ADDENDUM NO. 07

Date: 08.23.2024

**Westfield Washington School Corporation
Westfield Middle School West
Bid Package 02, BI:02 Building Concrete Work and BI:03 Steel and Railing Work
17707 Centennial Road,
Westfield, IN. 46074**

The Hagerman, Inc portion of this Addendum consists of the following information:

DRAWING NUMBER
S202A

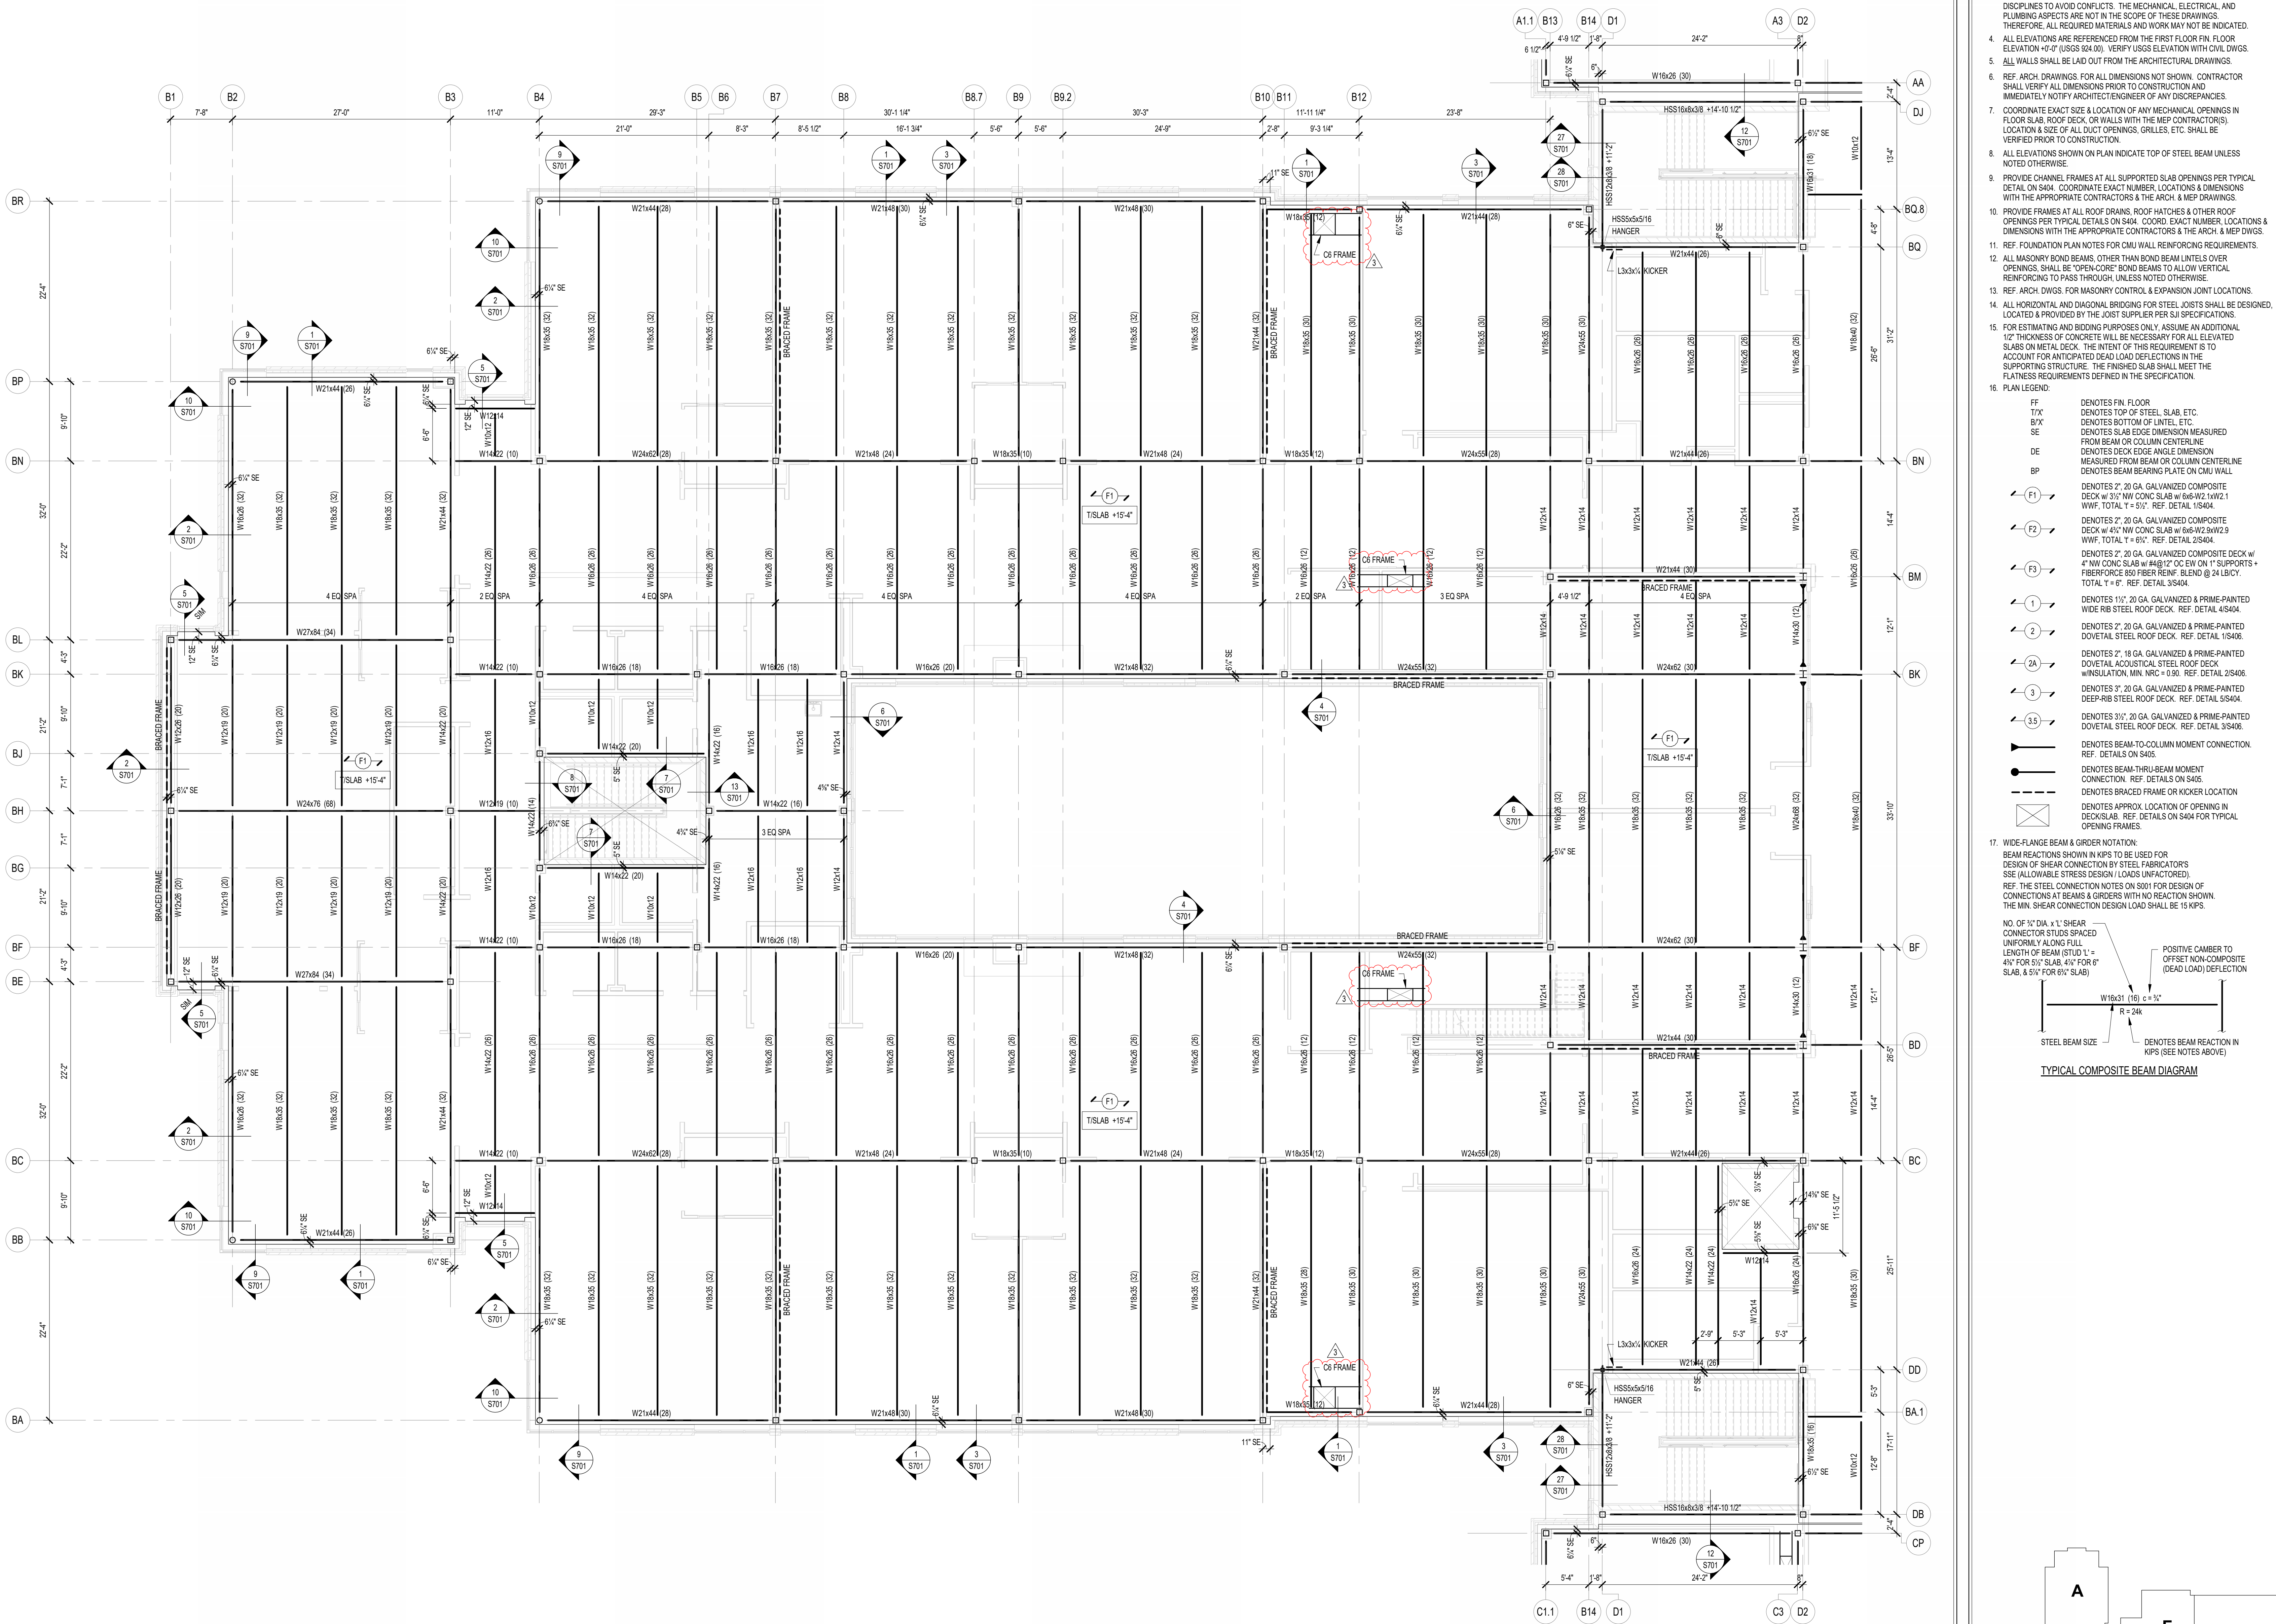
A. Add floor opening frames as shown.

DRAWING NUMBER:
S202C

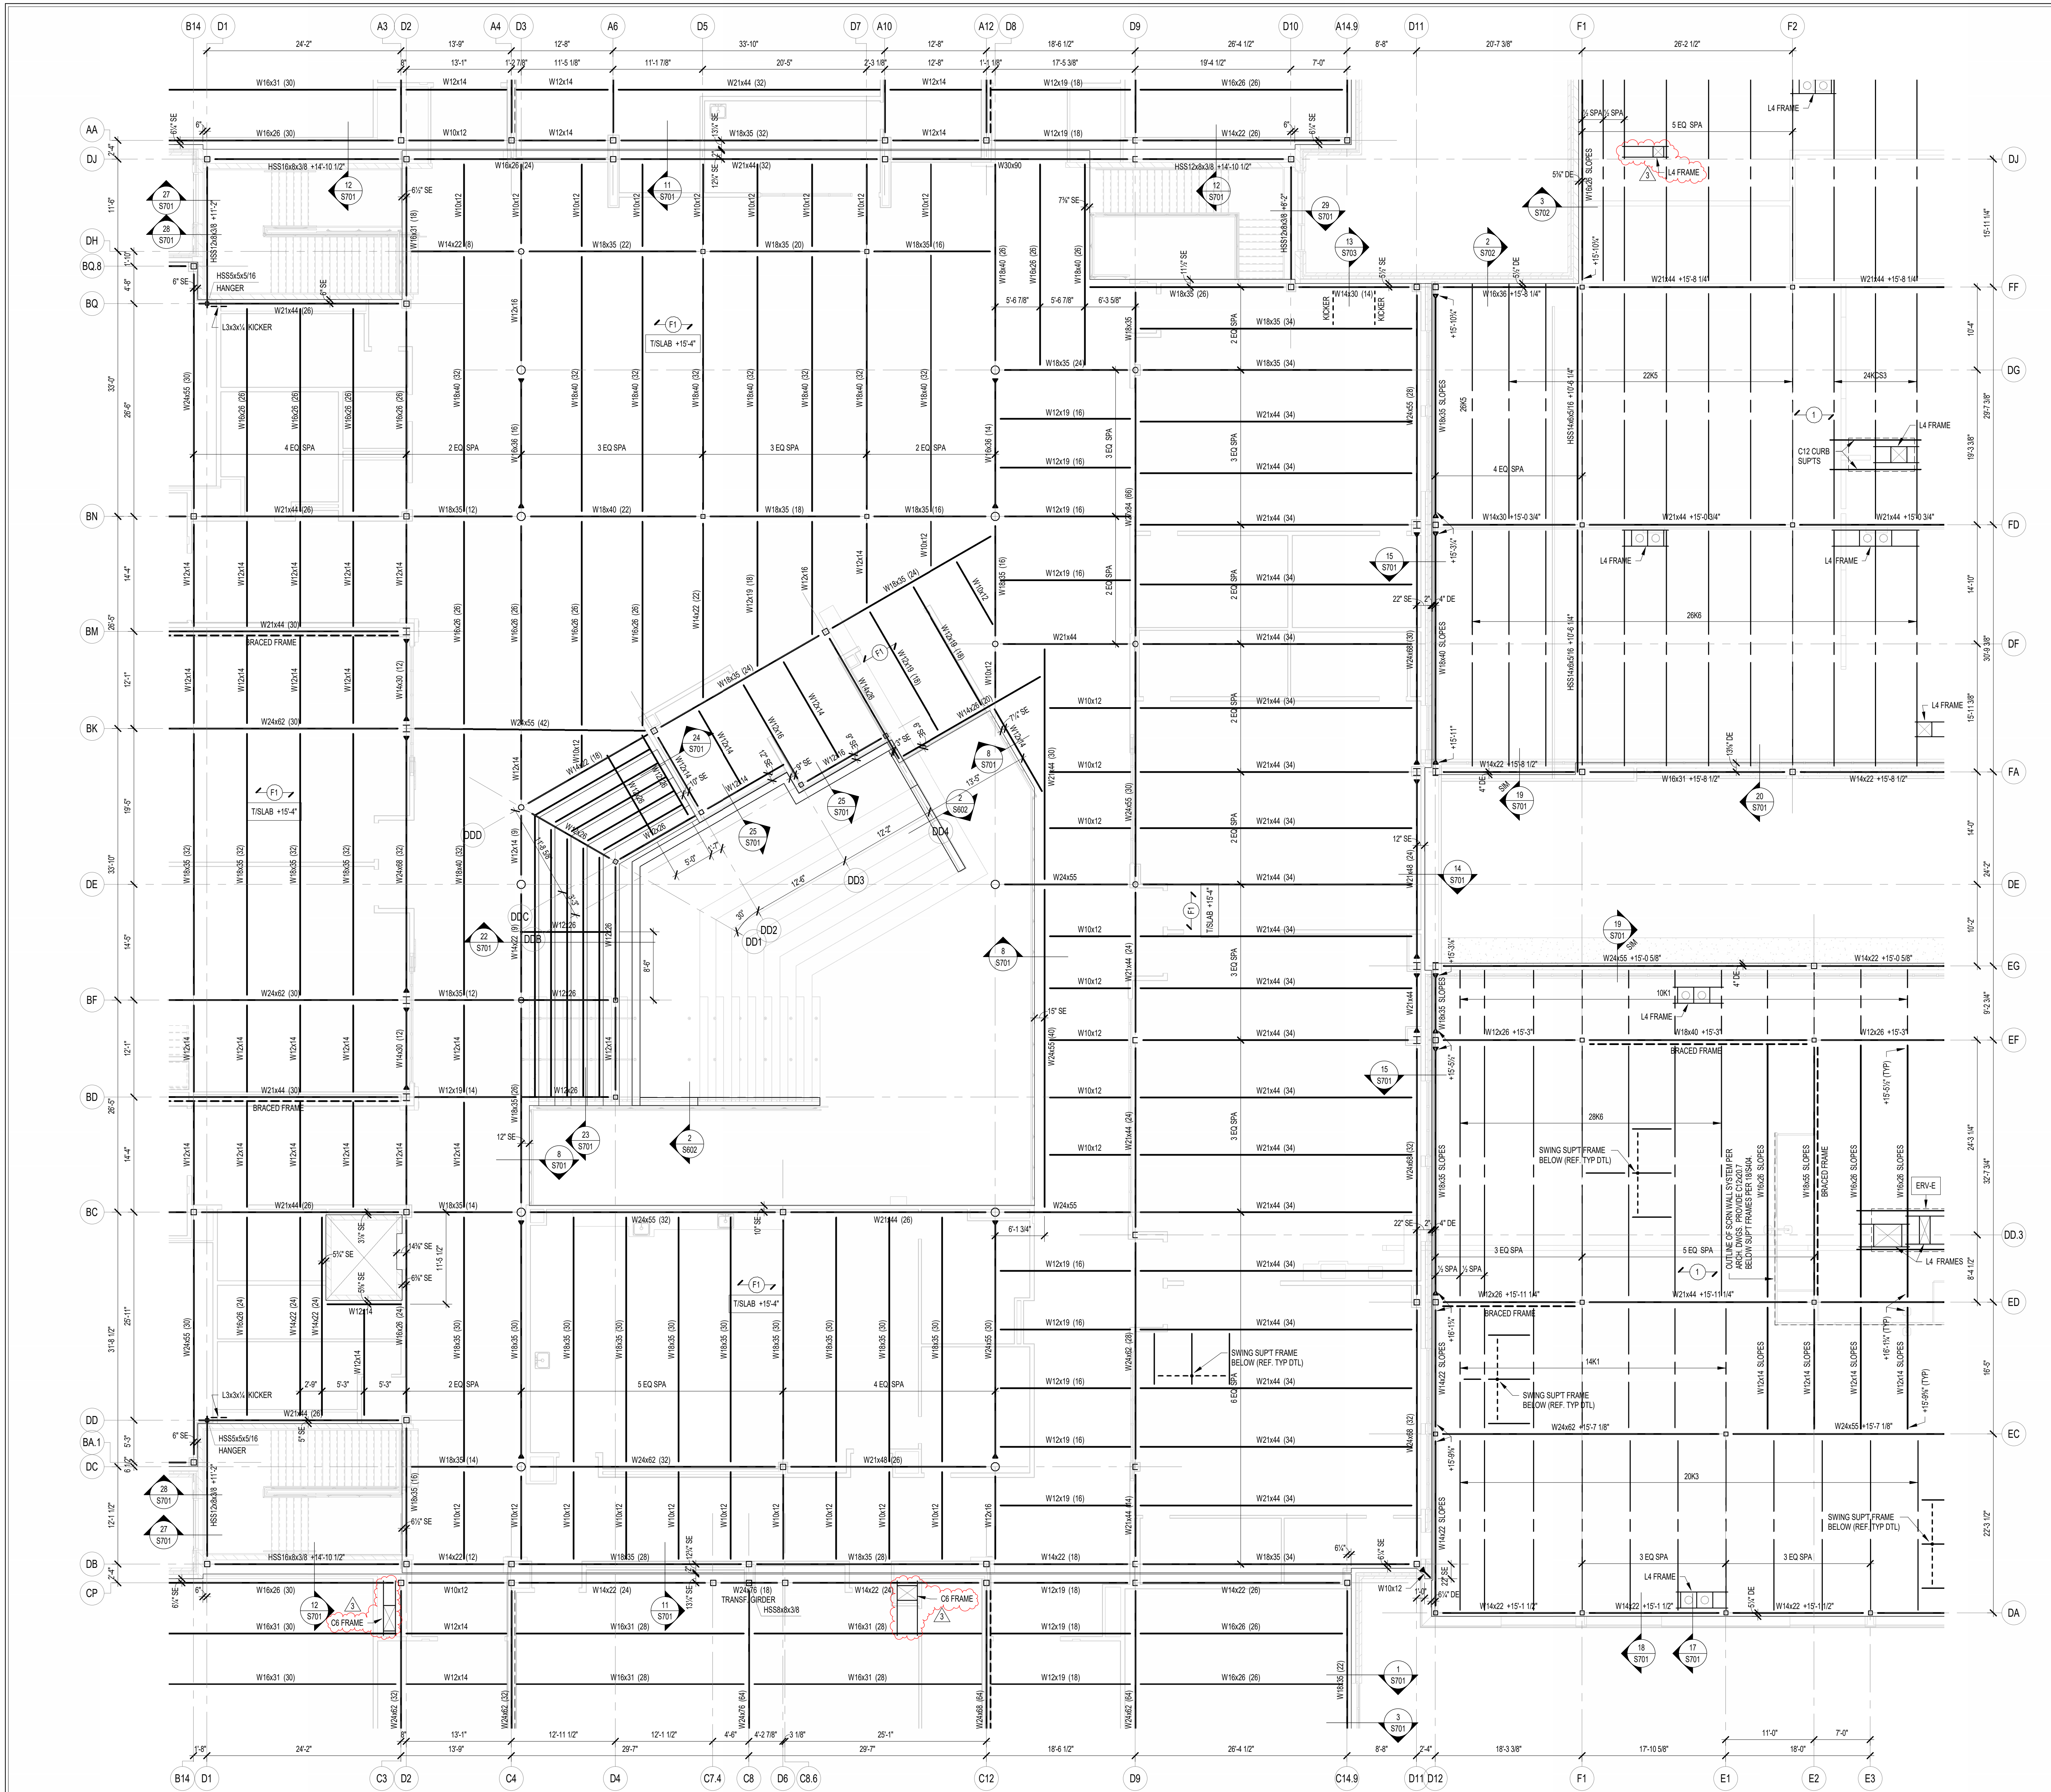
A. Add floor opening frames as shown.
